Access Compliance Report

Public Rights-of-Way

(Curb Ramps)

Intersection ID: 28345		Main Street: BACARDI_CT		Cross Street: HIRSCH_DR		Location:		NE	
ADA ID: 0FC1C13AB2CC		Ramp Type: Perp		Initial Pass/Fail: Fail		Overall Compliance: No		Severity Score: 30	
Codes/Mitigation Info/Possible Solution					Field Measurements/Component Compliance

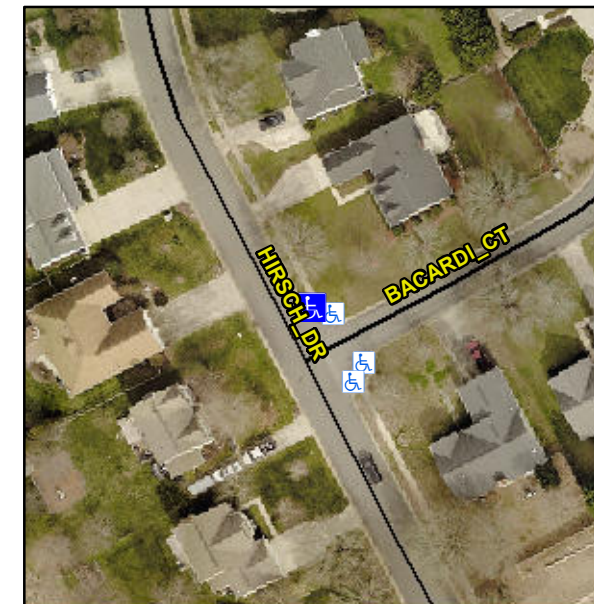
Not Found, R304.5.1, R304.2.2

Compliance	Description	Data	Compliance	Description	Data
N/A	Ramp Length (in)	93.0	No	Ramp Slope (%)	9.6
No	Ramp Width (in)	32.0	Yes	Ramp XSlope (%)	0.6
N/A	Flare Type LT	N/A	N/A	Flare Type RT	N/A
N/A	Flare Slope LT (%)	N/A	N/A	Flare Slope RT (%)	N/A
N/A	Flare Traversable LT?	N/A	N/A	Flare Traversable RT?	N/A
N/A	Landing Length (in)	N/A	N/A	DWS Provided?	N/A
N/A	Landing Width (in)	N/A	N/A	DWS Contrast?	N/A
N/A	Landing Slope (%)	N/A	N/A	DWS Length (in)	N/A
N/A	Landing X Slope (%)	N/A	N/A	DWS Full Width?	N/A
N/A	Landing Curb? (Y/N)	N/A	N/A	DWS Offset (in)	N/A
N/A	Shared Landing?	N/A			
N/A	Gutter Ponding?	N/A	N/A	Gutter Slope (%)	N/A
N/A	Gutter Lip Ht (in)	N/A	N/A	Gutter X Slope (%)	N/A
N/A	Painted X Walk1?	No	N/A	Painted X Walk2?	N/A
	X Walk 1 Direction	To SW		X Walk 2 Direction	N/A
N/A	X Walk 1 Width (in)	N/A	N/A	X Walk 2 Width (in)	N/A
	X Walk 1 Slope (%)	1.4		X Walk 2 Slope (%)	N/A
	X Walk 1 X Slope (%)	0.0		X Walk 2 X Slope (%)	N/A

Remove & Replace Entire Ramp.
